To: Neil Harkin, Queenstown Lakes District Council
From: Anita Vanstone (Strategic Growth Manager), Catriona Lamont (Spatial Plan Project Manager) and Cameron Wood (Senior Strategic Planner), Strategic Growth Team, QLDC
Date: 28 October 2025
Subject: Summary of the Te Tapuae Southern Corridor Structure Plan and assessment against the Fast Track Resource Consent for Homestead Bay, and Affordable Housing.

Part 2: Comparative assessment of the TTSC Structure Plan and the Homestead Bay Fast Track Resource Consent

Table 2: Comparison between RCL and Te Tapuae Southern Corridor Structure Plan

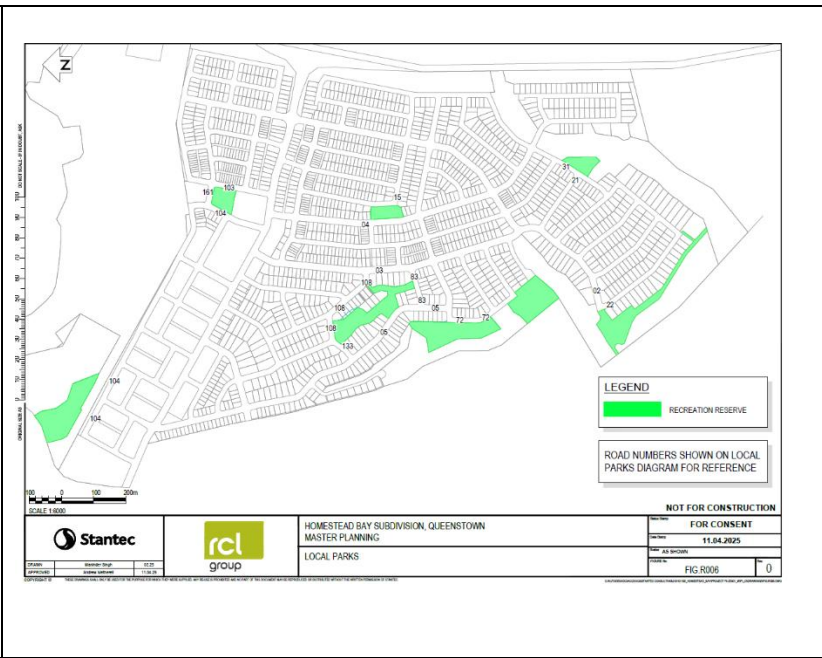
Open Spaces	The TTSC Structure Plan identified an open space network comprising of: • 2 Community parks (3ha and 2 ha) • 4 Local Park (all 0.5ha) • Sport and Active Recreation Reserve (2.8 ha) • Total: 9.8 ha <u>Local Parks:</u> 	The AEE says that there are 9 Recreation Reserve lots, however only 8 are shown in the reserve plan drawing. The 9th one is located to the north of Jack Tewa Park and is adjacent to the proposed future land wastewater disposal area, being Lot 9008 (0.21 Ha). Of these remaining 8, only 2 are currently non-encumbered. The total proposed reserve area is 8.4ha, however much of this is unsuitable as recreation reserve land (hilly, linear or encumbered). Further details are provided in the Parks Assessment. The recreation reserves are well distributed throughout the subdivision. The AEE says that Community Parks are greater than 1Ha. QLDC require community parks to be between 2 – 3 Ha (while previous community parks as small as 1.5 Ha have been accepted, this is only where all 1.5 Ha is usable and there are no constraints (i.e. gradient, no underground services or overland flow paths etc.). Local Parks are required to be between 0.3 Ha and 0.5 Ha.

wastewater disposal
9004	0.36	Local Park	3Waters easement (at edge of park)
9005	1.36	Local Park	Non uniform shape, changing gradient
9006	0.38	Local Park	
9007	0.43	Local Park	
9008	0.21	Community Park	Close proximity to wastewater disposal
9009	1.57	Community Park	Easement and designation in favour of Aurora

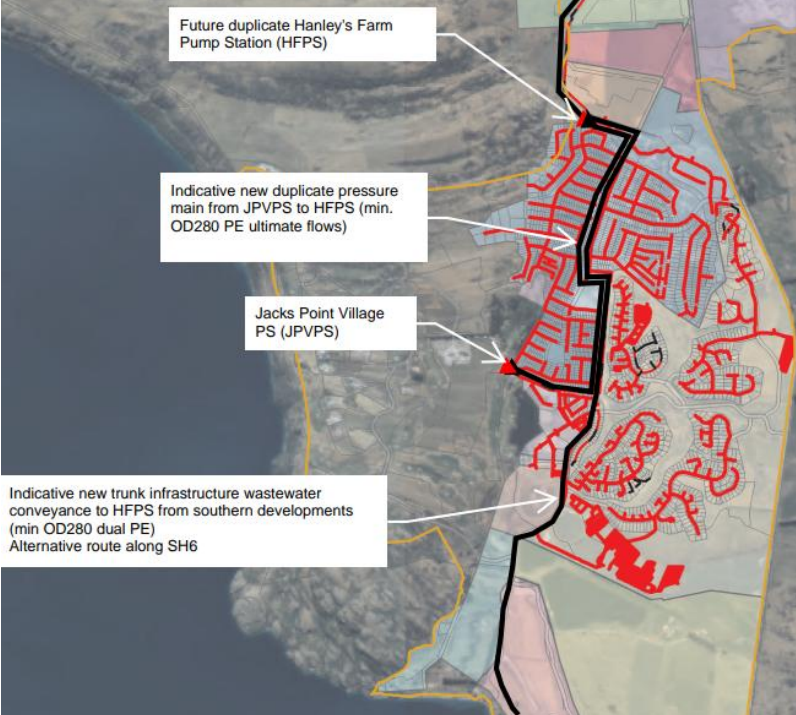
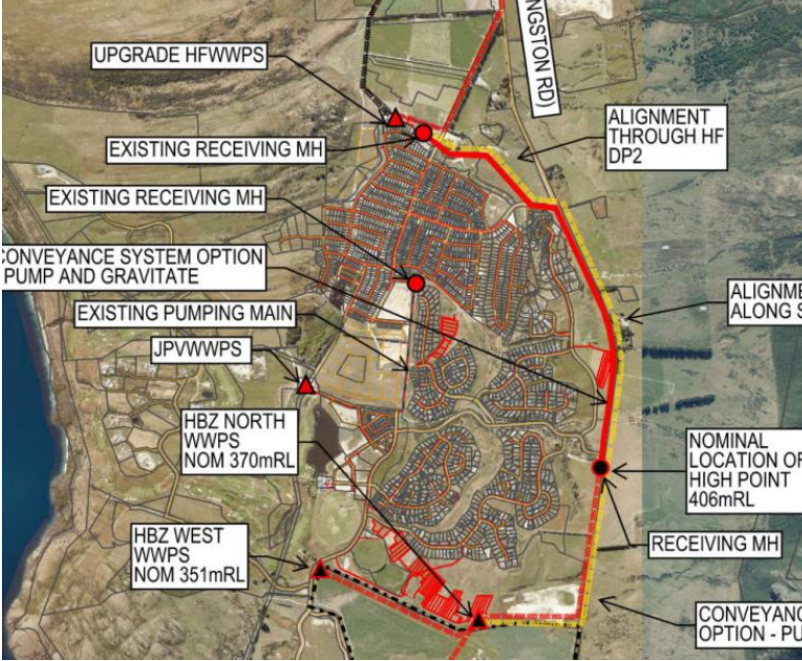
Community Parks Zoning  Sport and Active Recreation		
<i>Infrastructure – Three Waters</i>			
Wastewater	The Structure Plan endorses a whole of corridor approach to wastewater, with all new connections connecting into Council’s reticulation. This involves constructing reticulation in the south of the corridor to the undeveloped land, and connecting into Council’s Hanleys Farm Pump Station (HFPS) in the north. In the short and medium term, wastewater will be pumped to Shotover WWTP and in the long term (10+ years) this will either	Two options for wastewater treatment and disposal are included in the application. The AEE describes Option 1) as an onsite wastewater solution with a wastewater treatment plant on Lot 12, with onsite land disposal within Lot 8 and Lot 12. The total land available for disposal is shown as 29.7ha.	Option 1 – Low This option (including its feasibility) is assessed in the separate Infrastructure Report.

continue, with duplication of the pump station and reticulation, or it will be pumped to a new WWTP in the TTSC. Both these options are feasible, however further work is required to confirm the preferred long term servicing option and also to confirm costing and funding. Neither option is currently subject to funding in QLDC's Long Term Plan. The preferred alignment on how to connect the developable land in the south to HFPS is along the valley floor. This is predominately driven by hydraulic reasons, as it would include pumping up approximately 15m of elevation, (oppose to 60m which would require 2 pump stations). Council acknowledges that in the short term, it would be disruptive to local residents, to construct a pipe along this alignment, however, the long-term operation of the one pump station lift 15m oppose to 2 pump stations required to lift a combined 60m has cost and energy and emission advantages. There is a risk that if RCL does not connect into the system described above, it becomes challenging, both technically and financially to expand the network to the other greenfield developable areas in the south. The same economies of scale will not be available if the onsite disposal option is taken. For context the developer yield for the other developable land in the south shown in the Structure Plan has a range of between 1800 to 2180 DUEs. The 3Waters consultants determined that disposing to land within the corridor is unsuitable, as a whole of corridor	4.55 Ha of that is an overlap of proposed wastewater land disposal area and the existing easement in favour of JPROA. The engineering feasibility report states that their WWTP could be upsized to support neighbouring developments, but the treated wastewater would be returned to their land for disposal. The areas required for onsite wastewater disposal does result in open space, however it will not be able to be used by the Recreation Reserve. Appendix B – Engineer Feasibility Report – Part 5 (Appendix F) describes Option 2) as reticulation to take wastewater flows from the development to Council's existing reticulation at HFPS. This includes a new (onsite) pump station and a new rising main along the SH6. RCL say the new pump station can be upsized to accommodate flows from other land owners. From HFPS, the wastewater would be pumped to the Shotover WWTP.	Option 2 – High (subject to further work) The principal of Option 2 aligns with Council's whole of corridor approach, however, further work is required to confirm the alignment of the wastewater main to Hanleys Farm pump station. Due to the significant elevation change along the SH6 alignment, two pump stations would be required. This would result in

approach, due to the variable permeability of the soils and the subsequent large land area required for disposal, along with likely shallow groundwater.		higher energy use, operational costs and higher emissions. An upgrade of wastewater conveyance through Frankton flats to the Shotover Wastewater Treatment Plant is also required. These are discussed in more detail in the comment provided by P&I.
--	---	--	--

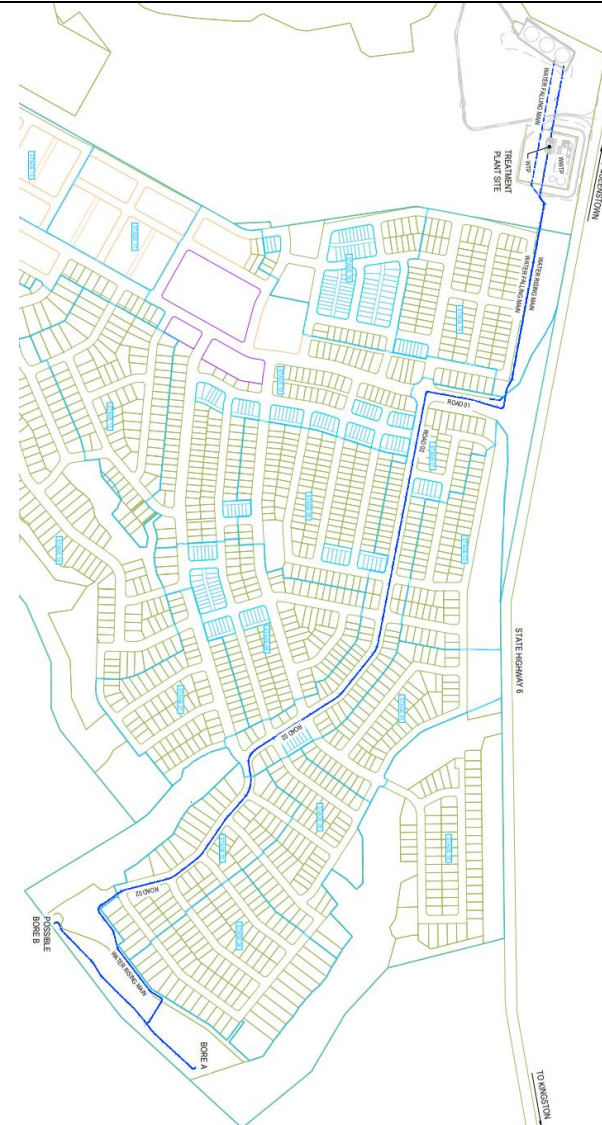
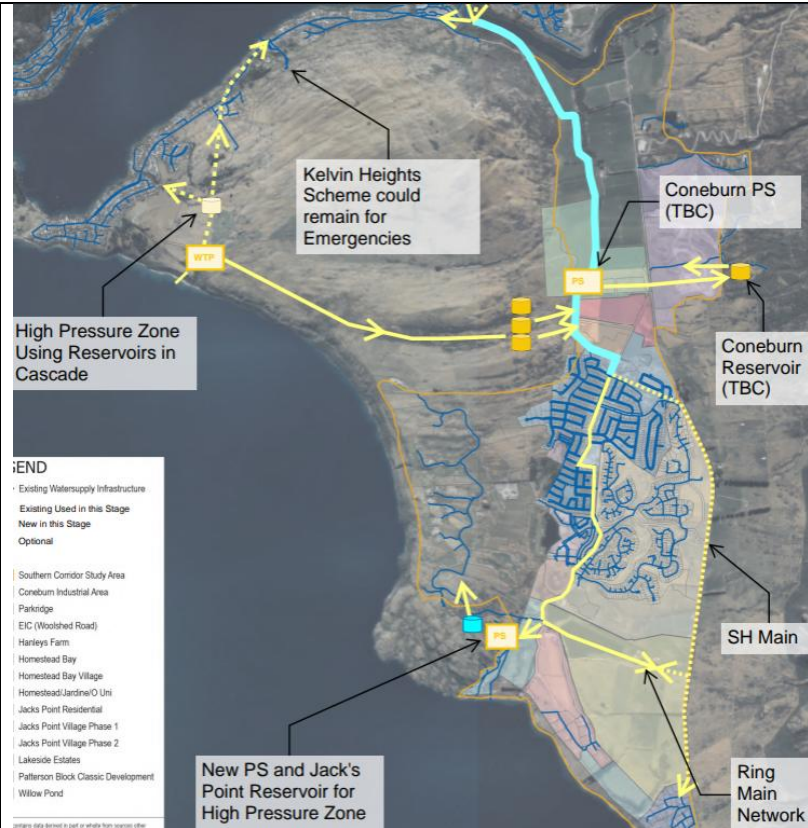
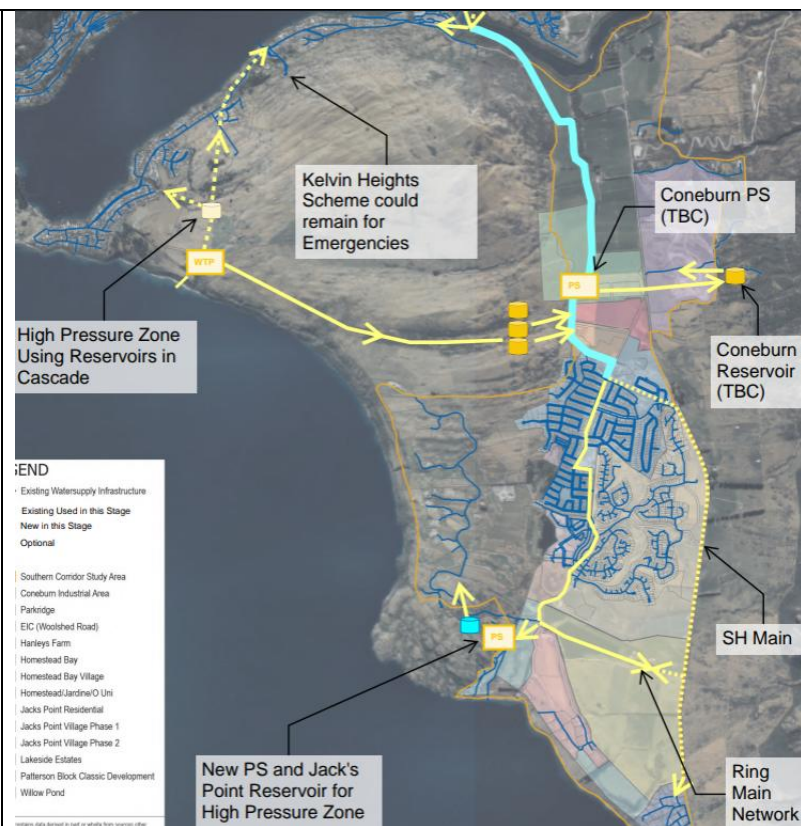
Water	The Structure Plan endorses a whole of corridor approach to water supply, with all new connections connecting into Council's reticulation. In the short term this involves constructing reticulation to the south of the corridor to the undeveloped land, (Homestead Bay) re-commissioning Council's Kelvin Heights Intake and constructing the Quail Rise Reservoir in Frankton; to allow two independent zones north and south of the Kawarau.	The RCL development proposes a ground water source to service their site, initially from a single bore with more being constructed as demand requires. The water will be pumped to a WTP which is relatively close to the proposed water reservoir. This system is designed to be stand alone.	Low However, there is the option of connecting the RCL bore into the QLDC network to supplement the

In the medium term it involves constructing a new reservoir. The location of this reservoir is positioned to allow for ease of connection to the long-term upgrade. The location is shown below on Peninsula Hill, between Kelvin Heights and TTSC. The long-term upgrade is to construct a new lake intake and WTP at the end of Kelvin Heights Peninsula. The 3Waters consultant considered a ground water source (which is advantageous for a treatment point of view), however, it was concluded that there wouldn't be a sufficient ground water source to service the whole of the corridor. This was later supported by the ORC peer review titled: <i>RE: RM24.355 / FTA063 – RCL Homestead Bay Ltd Wastewater Discharge (Effects on Groundwater) Technical Peer Review</i>, Dated: 13 August 2025.		supply, QLDC are currently doing further work for this configuration. However, the location of the RCL reservoir, far from the future source is not ideal.

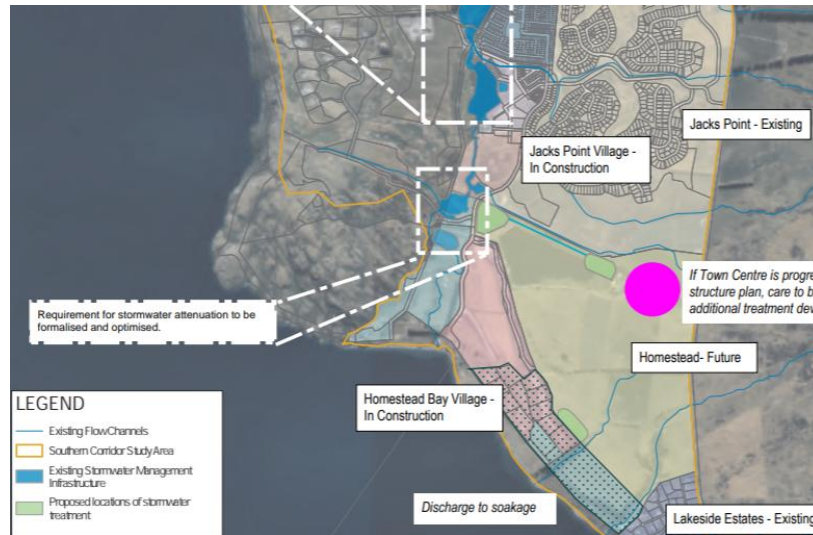
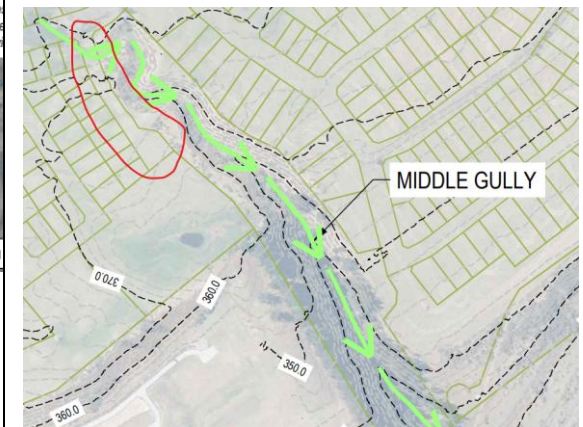
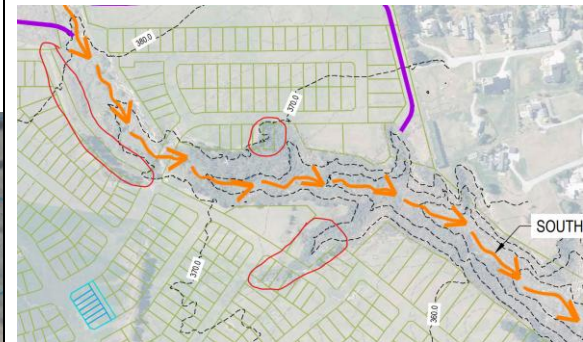
Stormwater	The Structure Plan endorsed preferred option of stormwater management in the TTSC is Distributed Nature Based infrastructure or treatment train with discharge to land. This includes: • Where possible manage contaminants close to source. • Conveyance of stormwater through natural treatment features such as vegetated channels and wetlands prior to discharge to Lake Whakatipu. <u>Northern Catchment (RCL Ref Northern Outlets (2,3,4))</u> Two attenuation basins are shown and their approximate locate align with RCL proposed Basin 1 and Basin 2. A wastewater disposal field is shown adjacent to the larger basin, Basin 1, and there are concerns that having both facilities in close proximity to each other could affect their efficiency. <u>Western Catchment (RCL Ref Northern Outlets (5, 6, 7)):</u> Consideration of roading layout, change in catchment size, and therefore secondary stormwater systems was not included in the TTSC Structure Plan assessment. It is feasible to reduce the area of the catchment, so the post development flows are as per the pre	The stormwater management approach adopted in the Proposal is summarised below. <u>Northern Catchment (RCL Ref Northern Outlets (2,3,4))</u> Stormwater runoff could have a potential negative impact on downstream Māori Jack Stream and adjacent properties. The proposed mitigation is to place attenuation basins in the subdivision to manage post-development peak discharge to pre-development discharges. The proposed development will attenuate runoffs through two ponds – one at each of Outlet 3 and Outlet 4. Basin 1 in the northwest corner and Basin 2 in the northeastern portion of the development. <u>Western Catchment (RCL Ref Northern Outlets (5, 6, 7)):</u> The proposed post development catchment areas will be reduced compared to the pre-development catchment area by earthworks and new primary and secondary stormwater systems inside the subdivision development. These outlets will	A full review of the Proposal has not been undertaken, but it is understood that this would be done at Engineering Acceptance Stage as per Condition 17. <u>Northern Catchment</u> High – subject to further detailed review during Engineering Acceptance <u>Western Catchment</u> High – subject to further detailed review

development flows. However, if attenuation is required, it would be in close proximity to the ww disposal area in Lot 9027 and be on the Recreation Reserve. <u>Southern Gullies (RCL ref: Southwestern Outlets 8, 9, 10, and Southern Creek Outlets 11, 12, 13):</u> The TTSC stormwater consultant has said that a minimum 6m offset from the top of the gullies is required to allow for stormwater access and maintenance. The TTSC ecologist identified the importance of these two large ephemeral gully systems, including providing connectivity between the lakeshore and the terrestrial habitats of the Remarkables Station QEII shrubland. These gullies are erosion prone and management of them and their soils should ensure that their capacity to accept and transfer stormwater is comprehensively integrated and mimics natural hydro systems, while incorporating opportunities to reinstate indigenous biodiversity that may help attenuate the impacts of surface overland flows. To further protect and enhance the ephemeral gullies planting along the gullies should be at least 20m in width, with sufficient width in the planting to allow for public access to be established through the margins or adjacent to the plantings. The public access shown in the gullies in the Proposal is not supported for ecological reasons.	have decreased runoffs post-development. Therefore, no attenuation is required. <u>Southern Gullies (RCL ref: Southwestern Outlets 8, 9, 10, and Southern Creek Outlets 11, 12, 13):</u> Erosion mitigations methods are described in Section 2.2.2 of Sppendix B – Engineering Feasibility Report – Part 5 – Appendix A, dated 5 September 2025, which states: <i>mitigation methods will be used to spread flood flows across the gully floor width, reduce the effective channel gradient and thereby reduce peak velocities, increase the gully roughness in shallow-depth flows to reduce velocity, and line the gully floors with well rooted vegetation and rock placements to provide protection against water scour and erosion</i> No mention of required offsets from the top of the gullies were references in the erosion mitigation. In instances this could be mitigated with no build areas, however, not ideal as it results in the areas required for ecological reasons and stormwater maintenance to be in private ownership. Areas where development is shown in close proximity to the gullies is highlighted below. Additionally, having the trails through these gullies would result in constant disturbance to the habitats of fauna and flora.	during Engineering Acceptance <u>Southern Gullies</u> Low – concerns regarding the offsets from the roads and lots from the gullies. Concerns regarding the public accessways shown in the gullies.

The current location of residential lots and roading layout in the Proposal would prohibit access for stormwater maintenance and degrade the ecology of the ephemeral gullies. Special Condition 6 of the OIO Assessment Report noted the Environmental Benefits of the proposal to purchase this land to be weak.

SH6 intersection

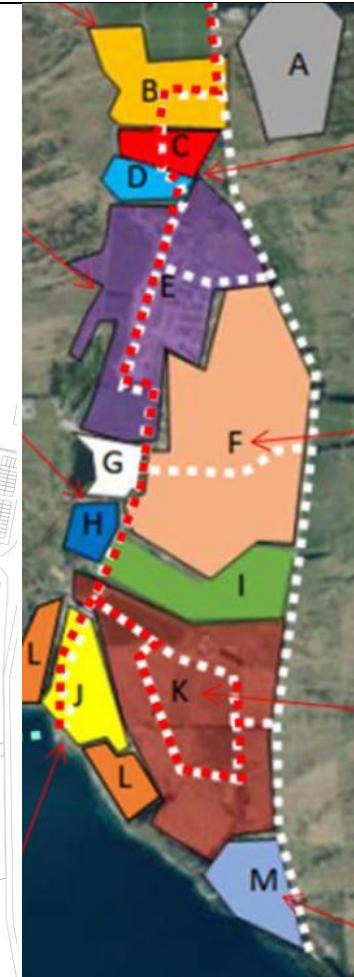
The location of the SH6 with the development is similar for the Structure Plan and the RCL development. Both show this intersection as a roundabout. Consideration for the provision of a future a bus priority lane is included in the Structure Plan.	This new single-lane access roundabout would be built during the first stage of construction. The design layout would be similar to the SH6/Park Ridge roundabout, with single lane approaches on all arms, and around a 44 metre inscribed circle diameter.	
	<u>Connectivity East to West</u> Connectively from Homestead Bay Road to the SH6 is similar in both the structure plan and the Proposal. <u>Connectivity southwest</u> The Structure Plan shows the future provision to the south-west highlighted below in yellow. This was selected as it would provide a relatively direct route to the local centre at Homestead Bay and the Marina. Additionally, there is an existing access way to the boundary between this land to the south and RCL. This location is approximately in the middle of the development which is therefore well placed for a number of future lots. The proposed route from RCL is relatively close to the main route between Homestead Bay Rd and the SH6. This connection (highlighted in yellow) would not be possible with the RCL current layout due to the location of wastewater disposal.	<u>Connectivity East to West</u> Connectively from Homestead Bay Road to the SH6 shows a relatively direct route, east to west. The staging plan shows this connection being complete in Stage 11. <u>Connectivity southwest</u> The future provisions for connectivity to the south-west is highlighted below in the pink, in relatively close proximity to the east to west connection. 	<u>East to West – High</u> Connectively from Homestead Bay Road to the SH6 shows a relatively direct route, east to west. However, the proposals staging plan shows the connection from Homestead Bay Road to SH6 as being in Stage 11, therefore the internal connectivity with the wider TTSC through the internal spine road are will not be

realised until the later stages. <u>Southwest</u> - <u>Low</u> The Structure Plan connection to the land to the southwest (highlighted in yellow) would not be possible with the RCL current layout, due to the location of the proposed wastewater disposal.
	<u>Park and Ride</u> Implement Park and Ride at high-capacity PT stations, adjacent to SH6. This is intended to capture traffic from the south with a destination north of Kawarau River.	<u>Park and Ride</u> Park and Ride is not proposed along the SH6. It is considered for the ferry service, which would likely not be on RCL land, and therefore not shown in the Proposal.	<u>Low</u> Does not future proof the possibility of mass rapid transport or alternative

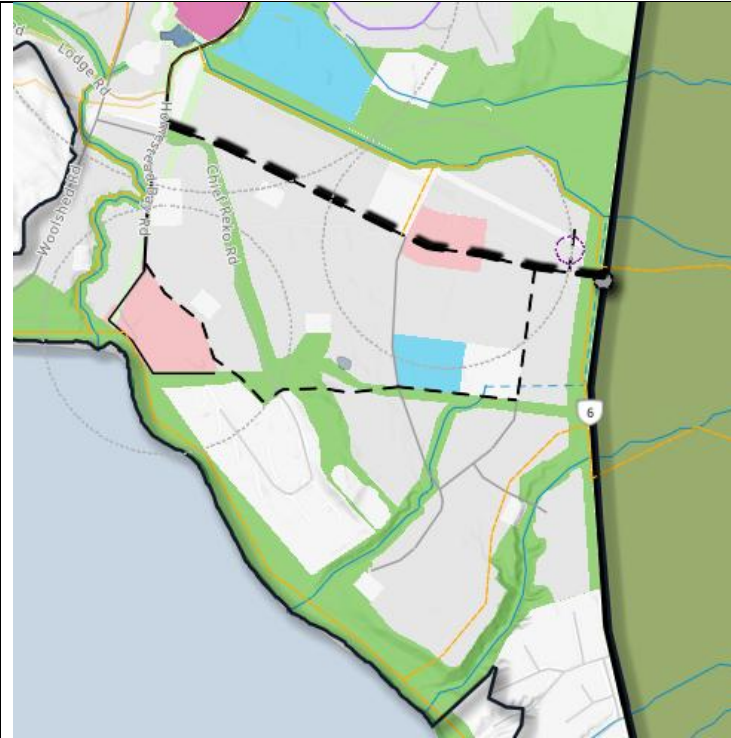
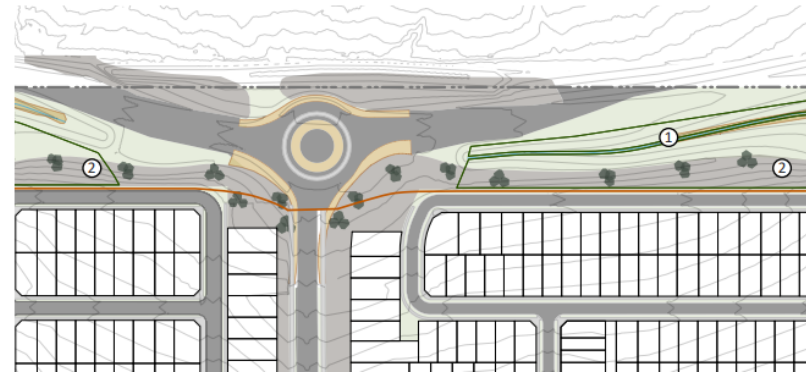
transport modes.
	<u>Active Travel</u> The Structure Plan shows the active travel trails in orange, and shows where and how they will link up to neighbour land parcels to the west and southwest. It includes a pedestrian crossing across the SH6, onto QEII land. The trails near the ephemeral gullies are shown in above, adjacent to the gullies. The ecology of this is discussed in more detail in the stormwater section.	<u>Active Travel</u> Walking and cycling networks are described as being within the road reserves and are shown in the Stantec Drawings. Trails through open spaces are shown in the Landscape Design documents. The landscape plans show the active travel routes going through the ephemeral gullies (which are also overland flow paths), oppose to outside, above the gullies.  The active travel trail does not connect into the neighbouring subdivisions. Special Condition 6 of the OIO requires a number of public access to be included. The one required along the SH6	Trails through open space - Medium Similar alignments, however, ecological concerns and maintenance concerns with the trails being in the gullies / overland flow paths. Limited connectivity of the trails to existing trails in the TTSC area Walking and cycling networks in road reserves This level of detail is not

appears to be shown in the Landscape Plans, however the full extent isn't clear. Another is required adjacent to the Homestead Bay Road, shown on the trail map on the line marked red below, this is not currently shown in the RCL plans.
